SI14.40-W-0011A

SI14.40-W-0011A	Service Information: Repair solution for pressure reducing valve in pump module of exhaust aftertreatment system	3.3.10
-----------------	--	--------

MODEL 930, 932, 933, 934, 940, 942, 943, 944, 950, 952, 953, 954 with CODE (MS4) BlueTec 4
MODEL 930, 932, 933, 934, 940, 942, 943, 944, 950, 952, 953, 954 with CODE (MS5) BlueTec 5
MODEL 970, 972, 974, 975, 976 with CODE (MS4) BlueTec 4
MODEL 970, 972, 974, 975, 976 with CODE (MS5) BlueTec 5

W14.40-1510-11

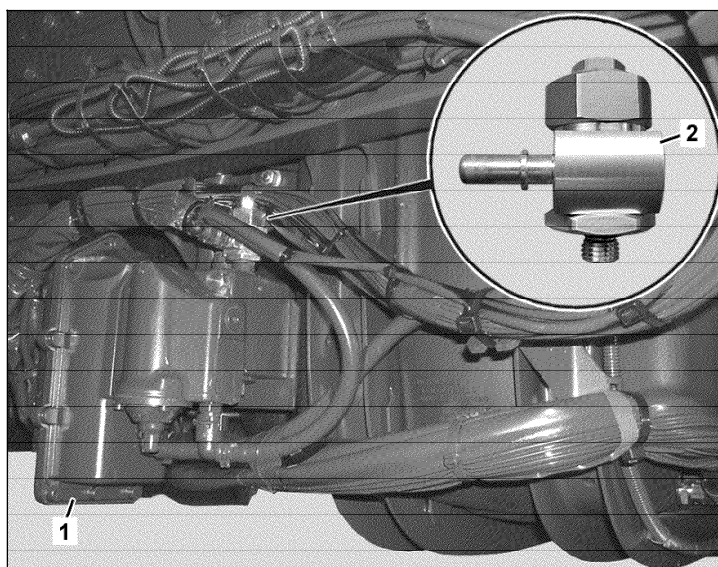
- **Pump modules with part number: A 000 140 04 78**
In the case of damage an external pneumatic pressure reducing valve (2) can be installed which takes over the function of the internal pressure reducing valve. This can also be replaced in the case of damage.

W14.40-1495-11

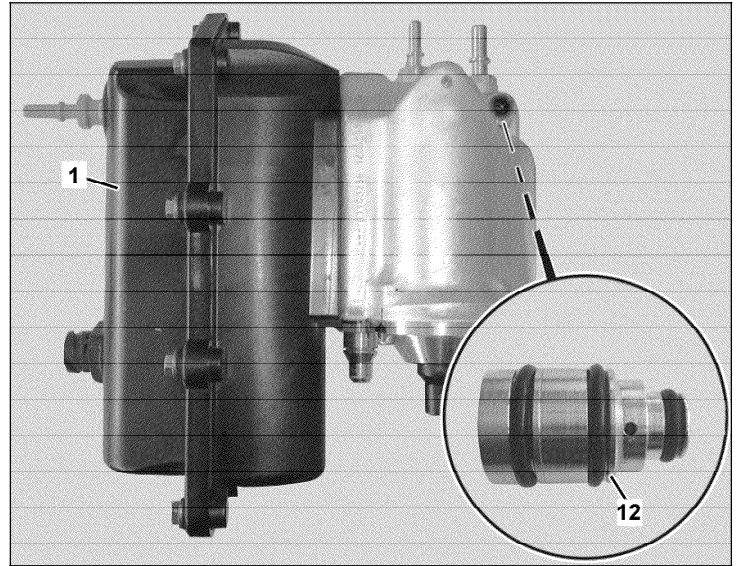
- **Pump modules with part number: A 000 140 05 78**
This pump module fitted since approx 07/2009 has an internal pneumatic pressure reducing valve in a diaphragm valve type of construction instead of the internal pneumatic pressure reducing valve (piston valve type of construction). The internal pneumatic pressure reducing valve (12) can be replaced in the case of damage.

W14.40-1511-02

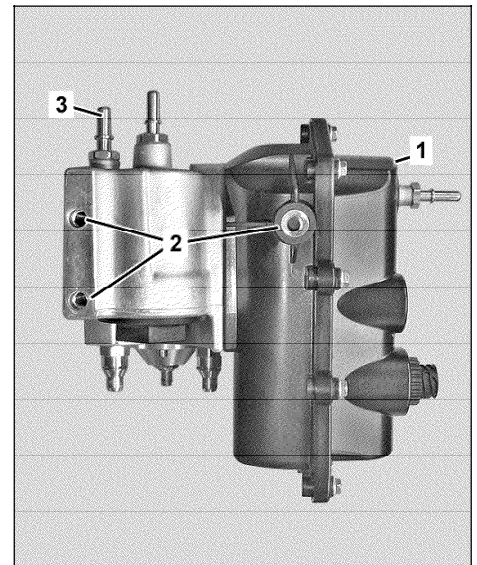
An altered diameter of the fastening thread (2) and the AdBlue return connection (3) on the pump module (1)

Since about the middle of August 2006 the following changes have been made to the pump module (1) in series production:

- Diameter of the bore with the fastening thread (2) for fastening the pump module (1) to the bracket altered from M12 to M10
- Outside diameter of the AdBlue return connection (3) altered from 7.89 mm to 9.49 mm.

W14.40-1512-11

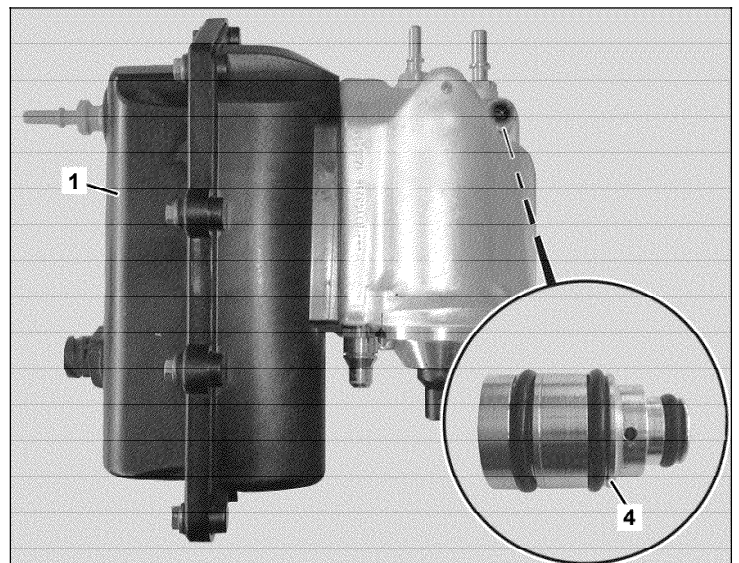
An altered pneumatic pressure relief valve on the pump module

Since about 07/2009 the following changes have been made in series production:

Instead of a pneumatic pressure relief valve of the piston valve type the pump module (1) is now fitted with a pneumatic pressure relief valve of the diaphragm valve type (4).

i Since about 07/2009 only the altered pump modules (1) will be delivered as a replacement part over the GLC.
